PL6

NON MATERIAL
AMENDMENT
PLANNING
APPLICATION
& CONDITION 4
DISCHARGE

44 A GLOUCESTER
AVENUE LONDON
NW1 8JD

2.2 CHANGES TO CONSENT-ED DEMOLITION FIRST AND SECOND FLOORS

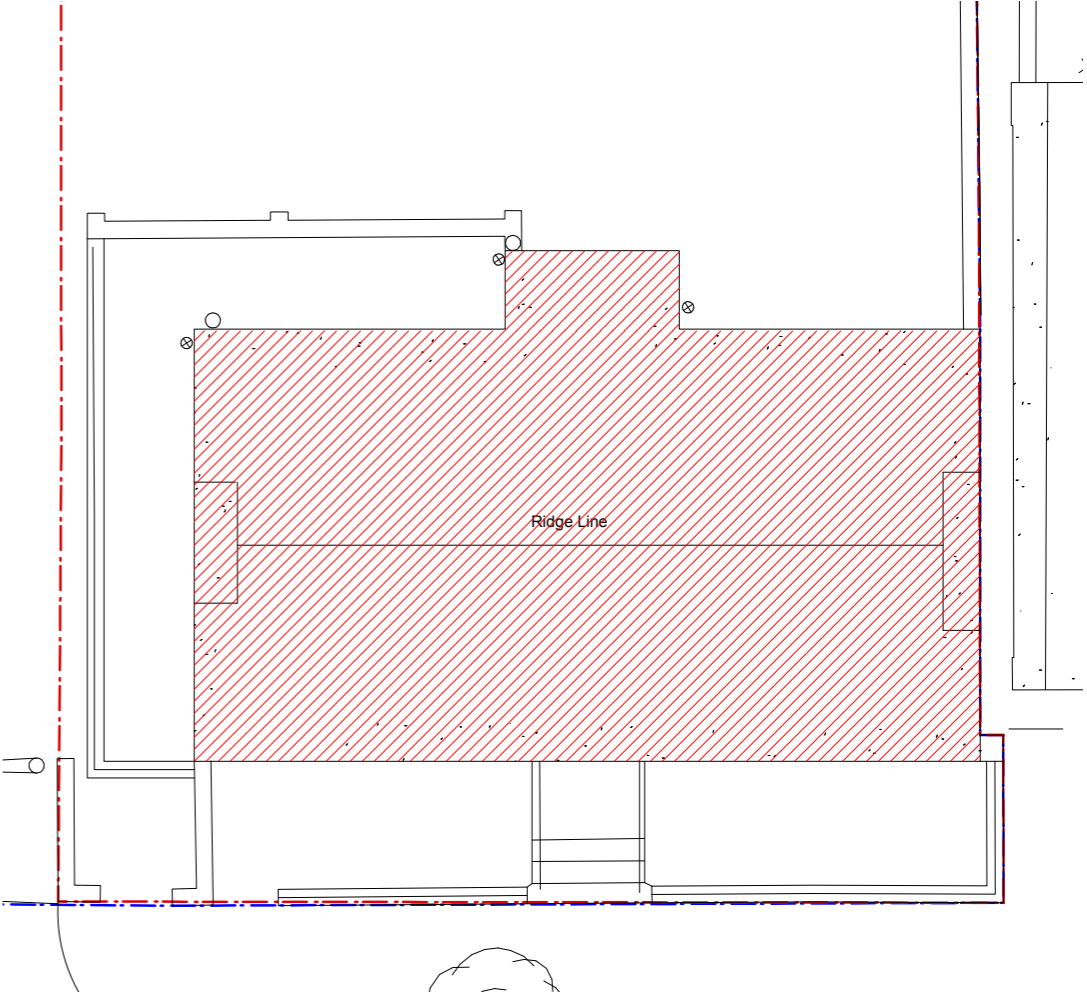
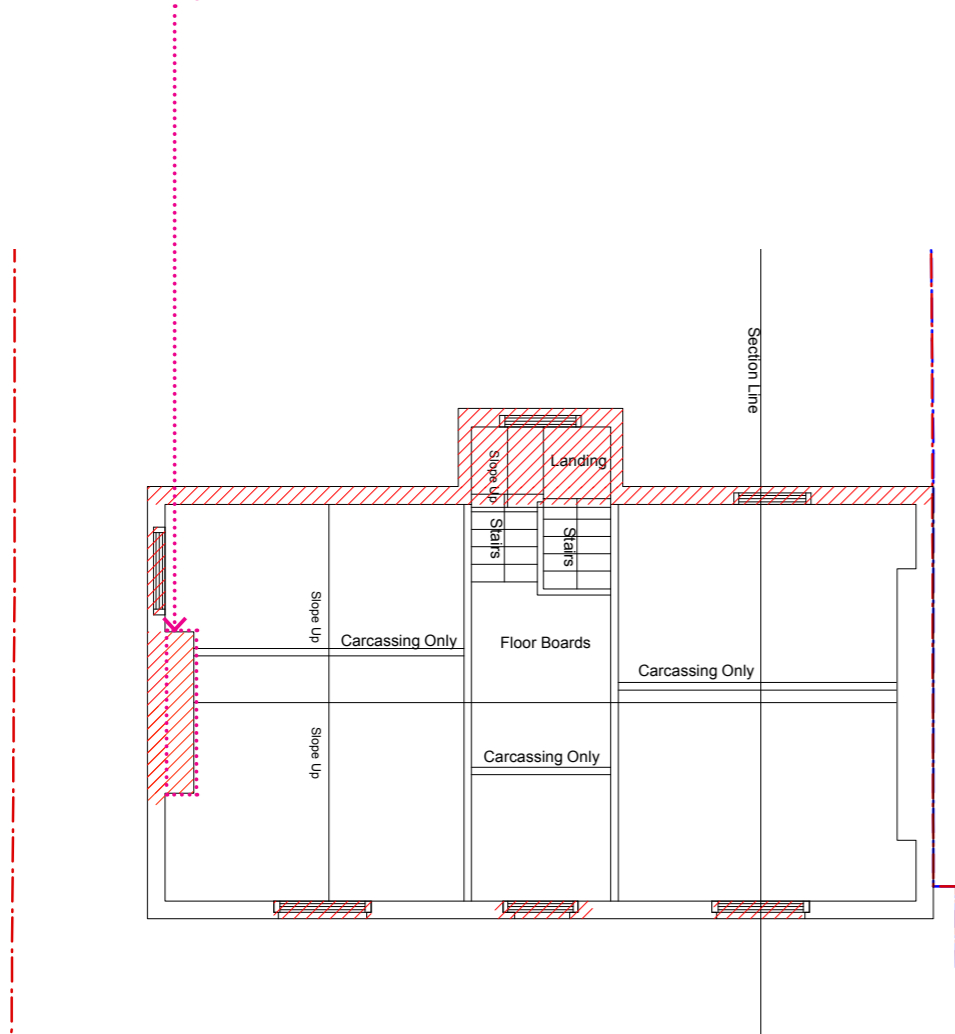
Additional opening made for the new window.
Internal chimney breast to be demolished due to poor existing condition

2.4 CHANGES TO CONSENTED DEMOLITION FRONT ELEVATION

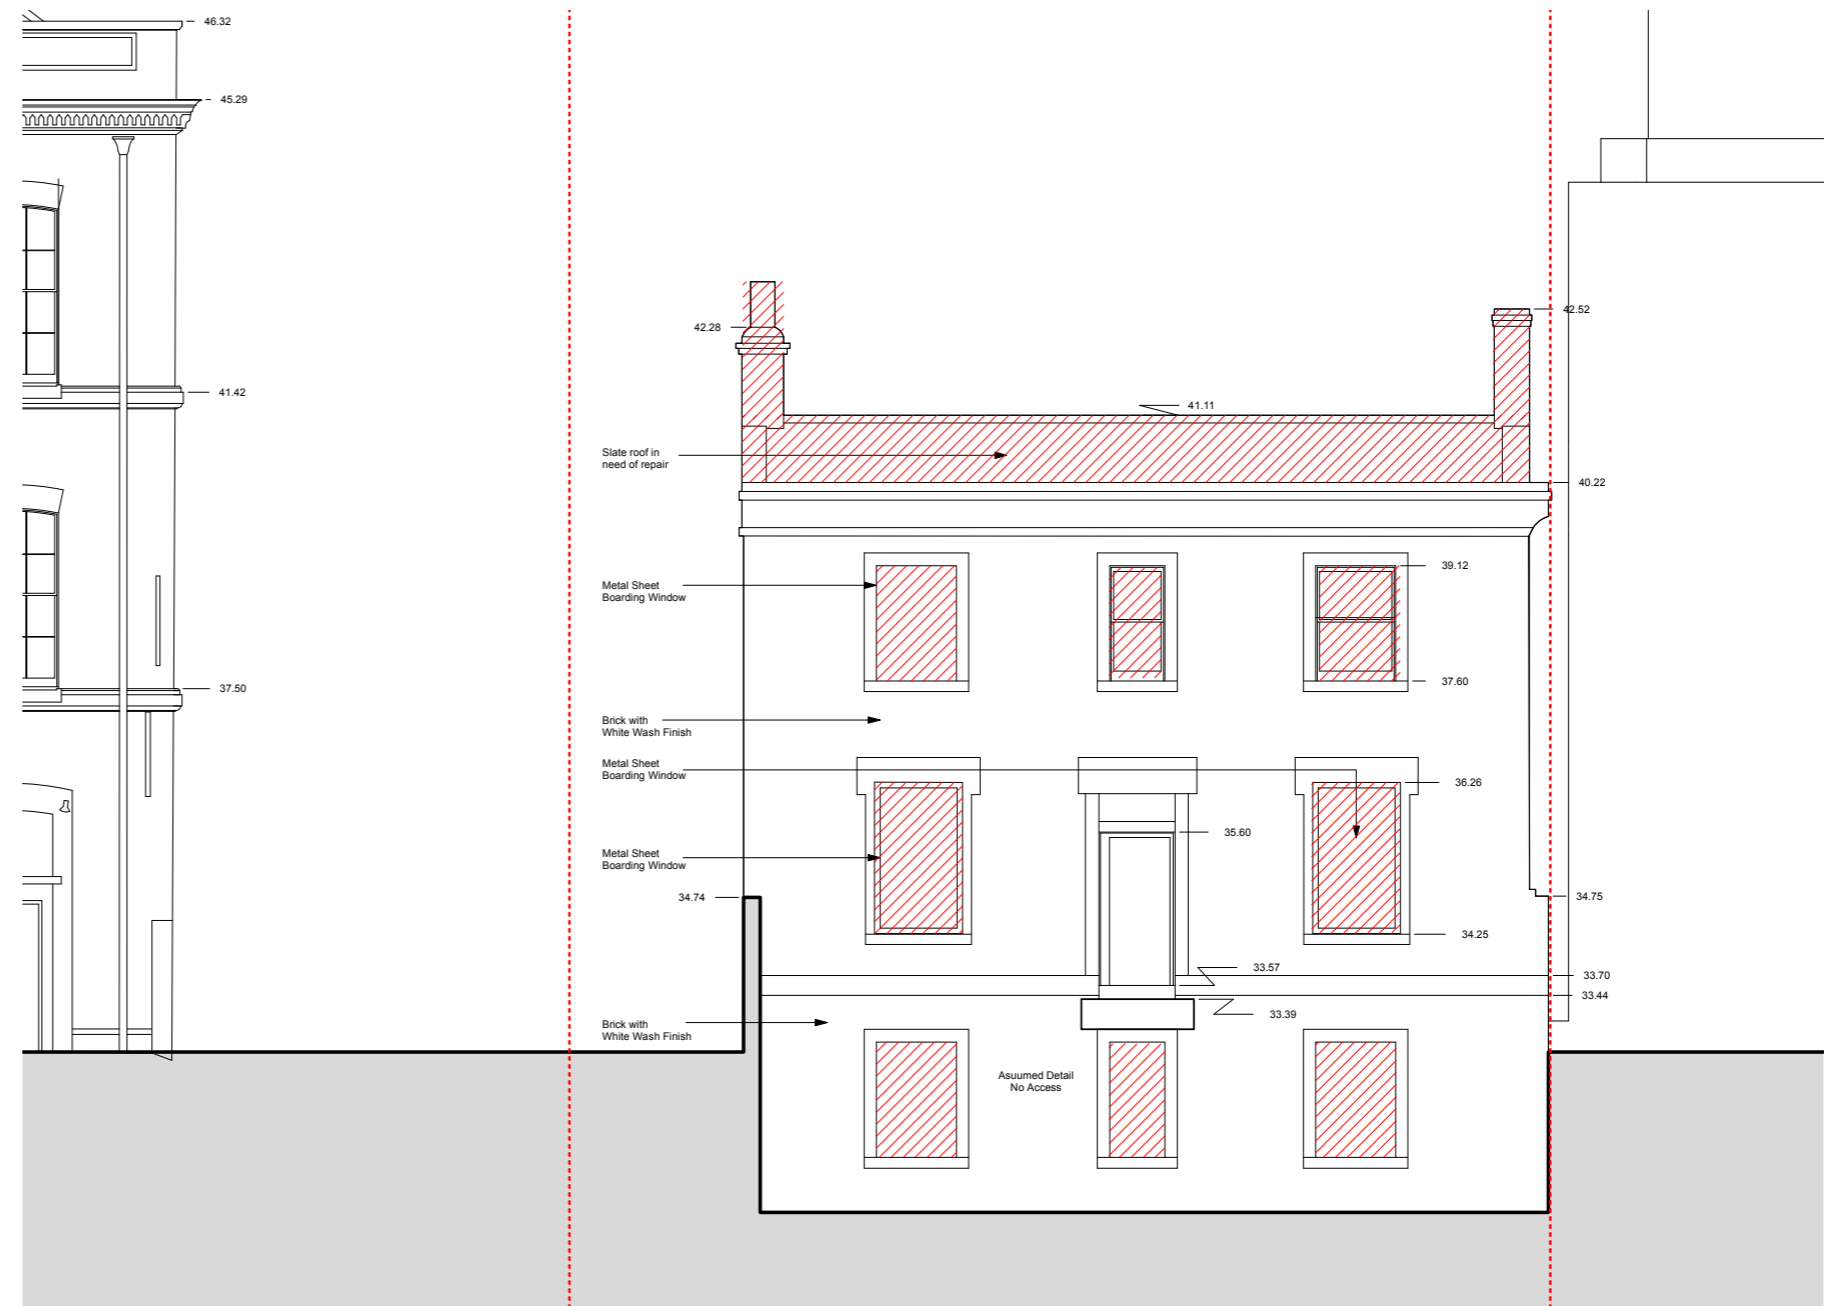
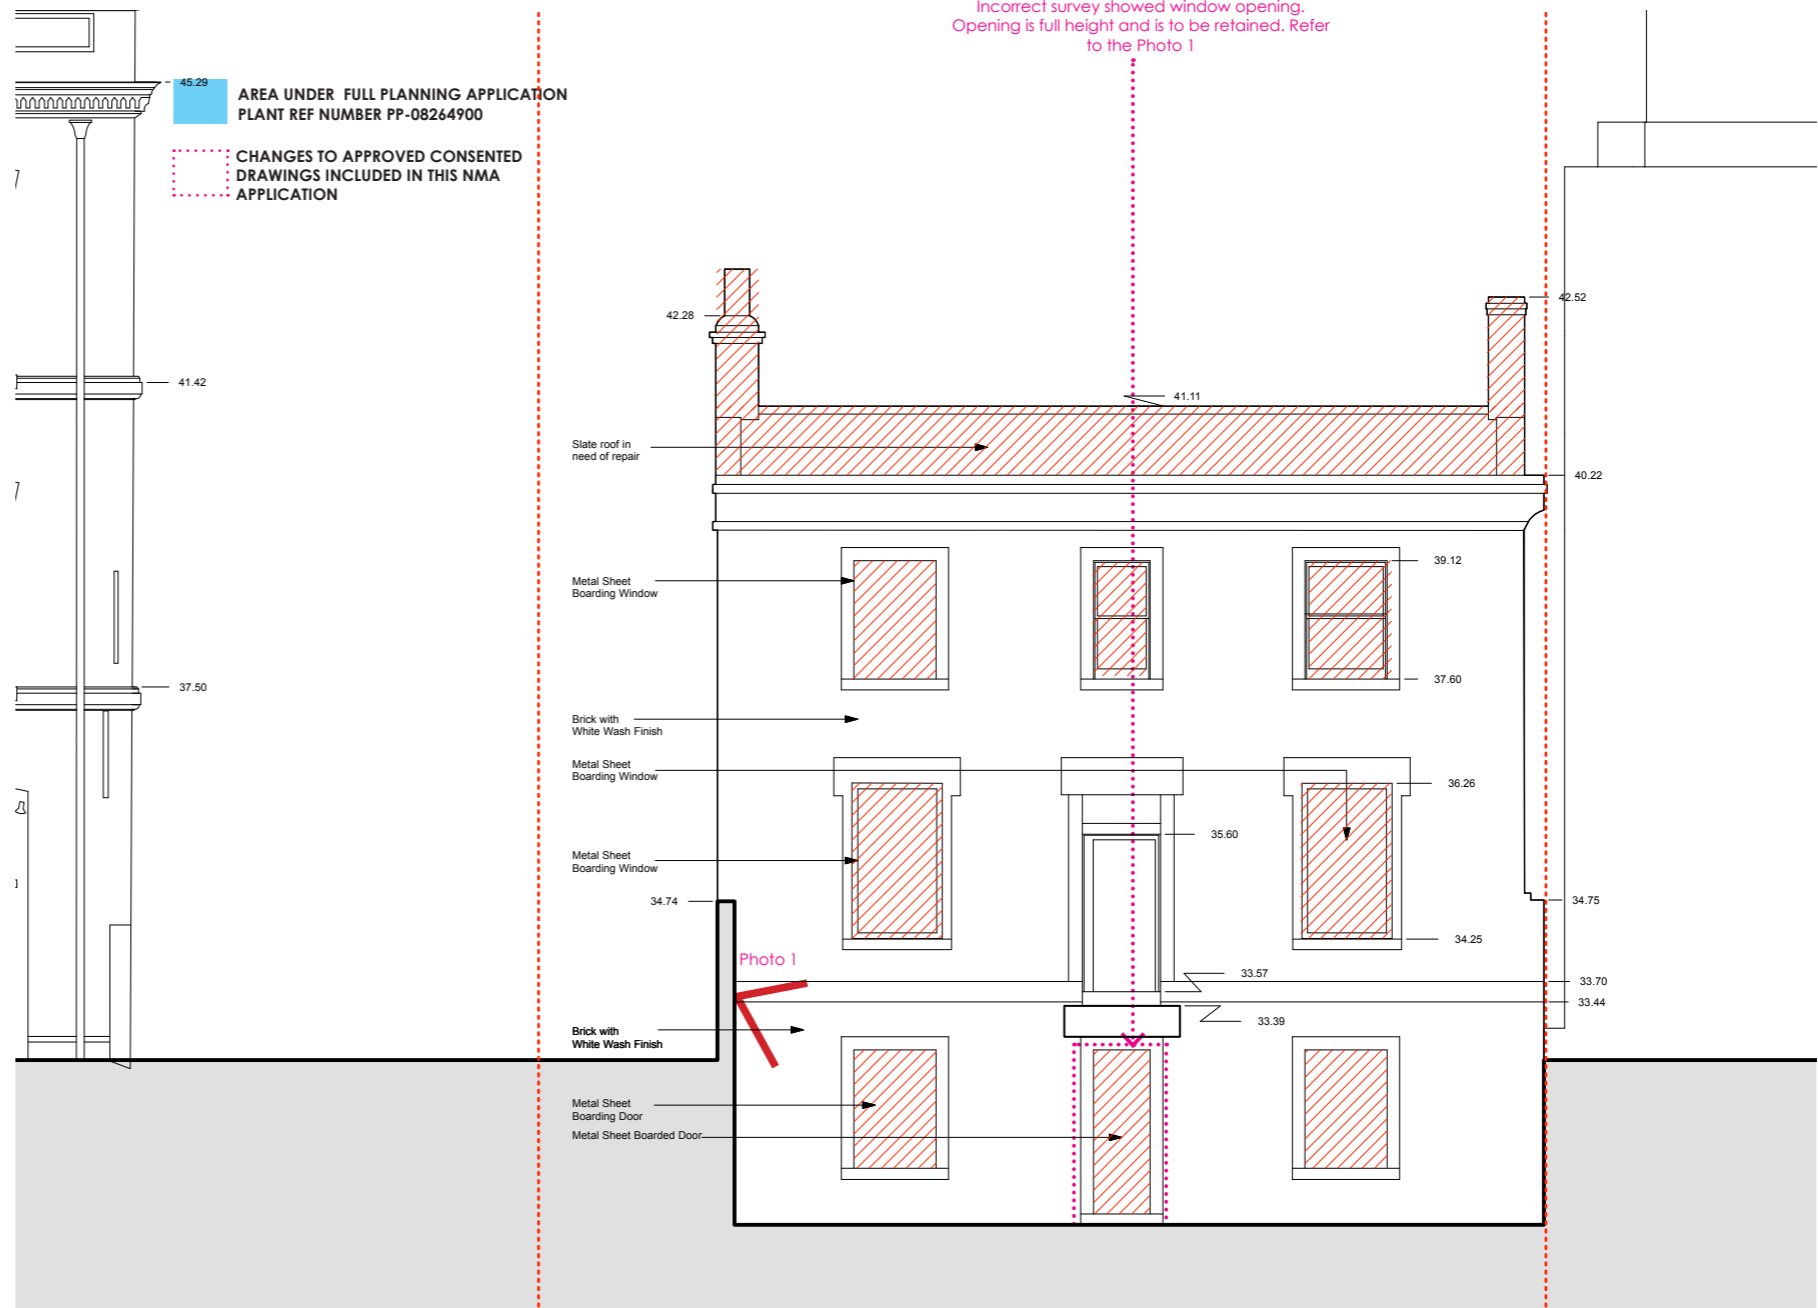
PHOTO 1. PHOTO OF THE EXISTING FULL HEIGHT OPENING

2.7 CHANGES TO CONSENTED FIRST AND SECOND FLOORS

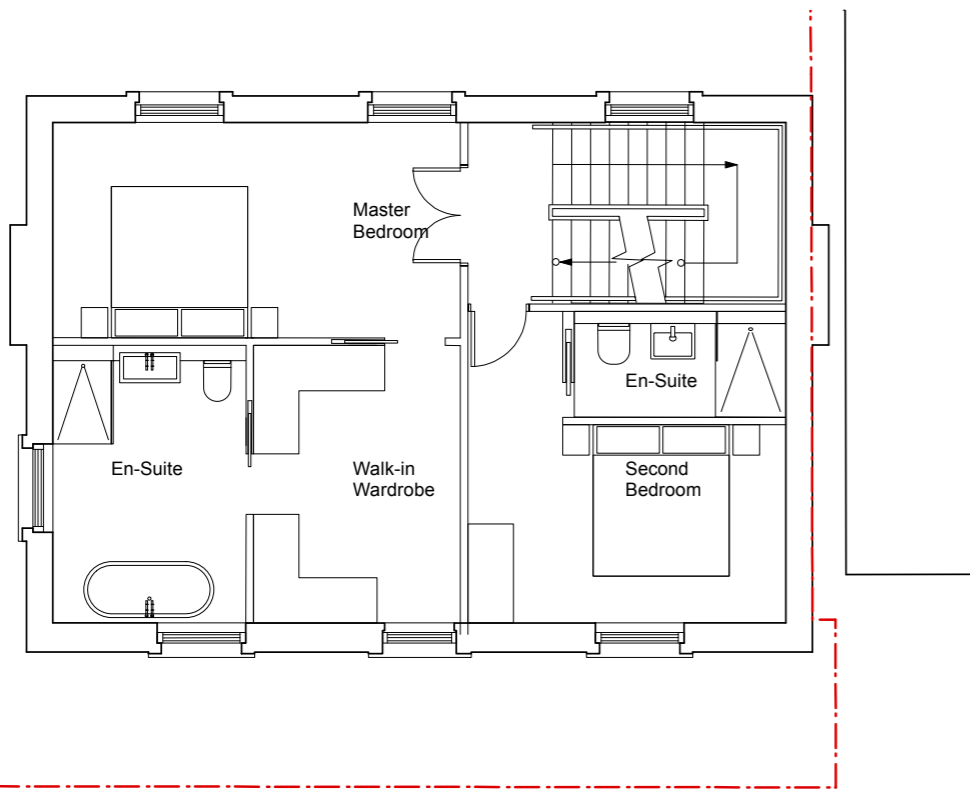
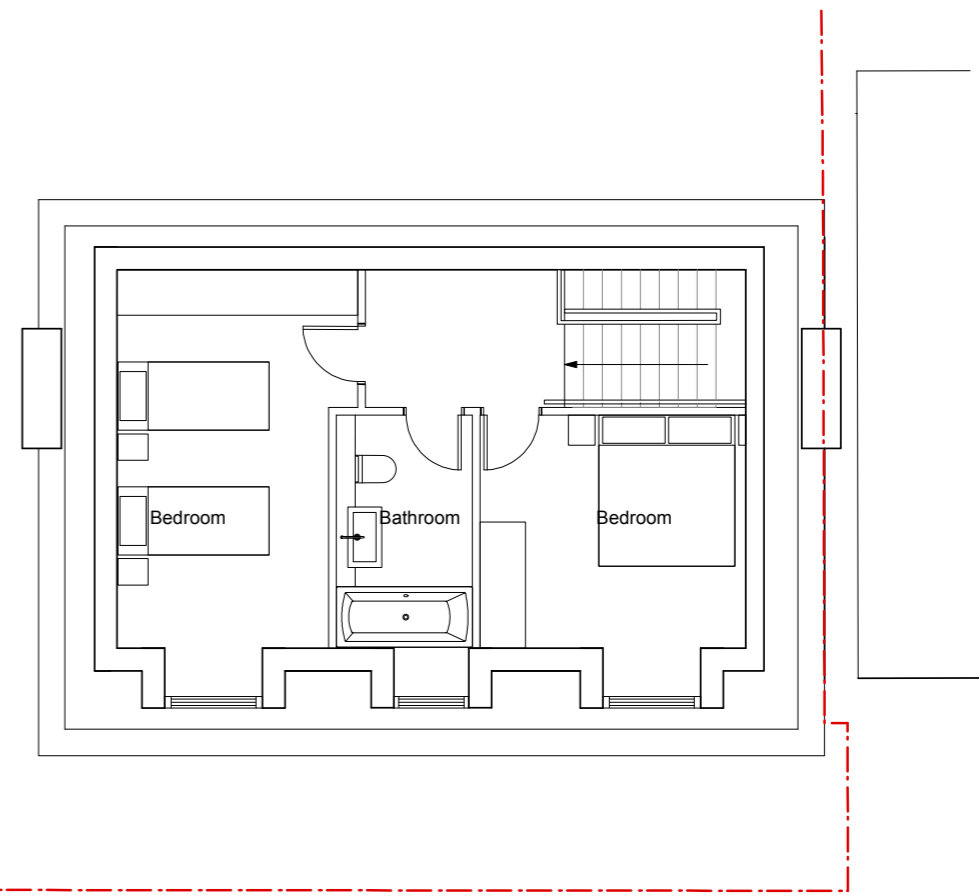
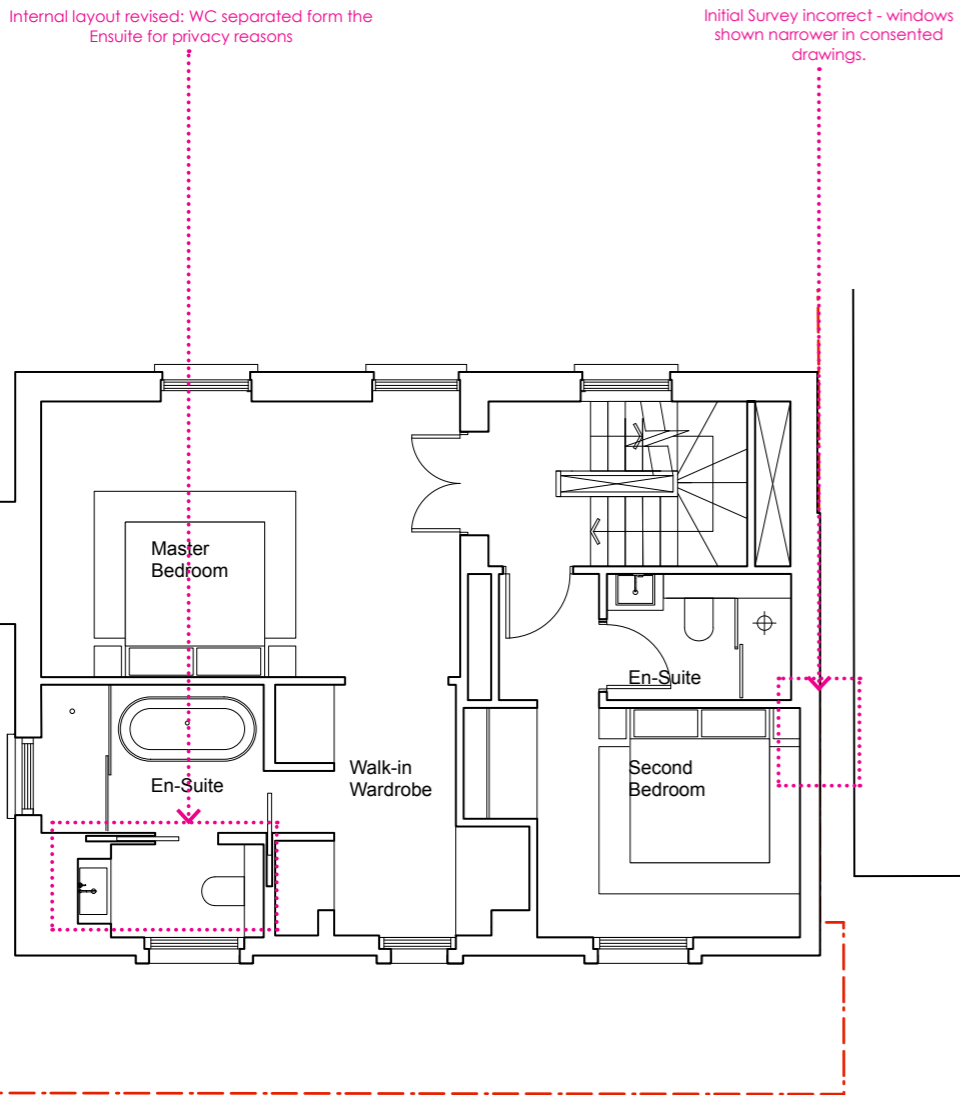
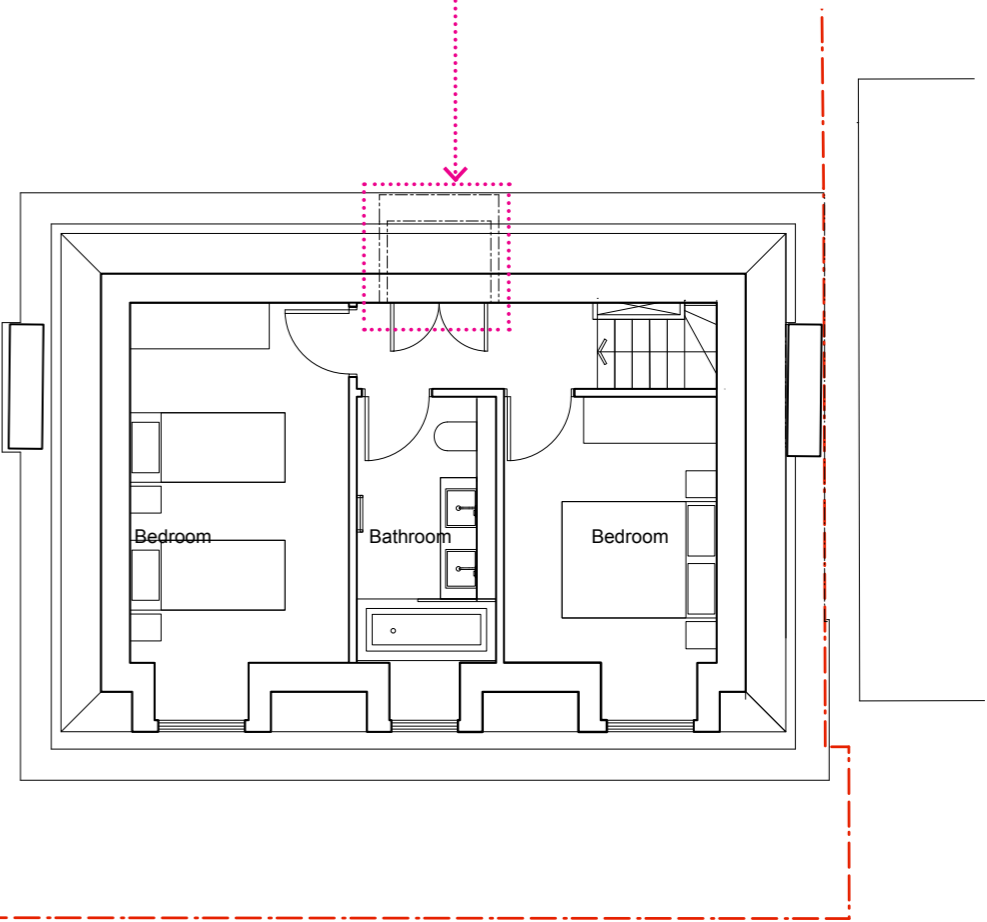
Internal under roof storage added
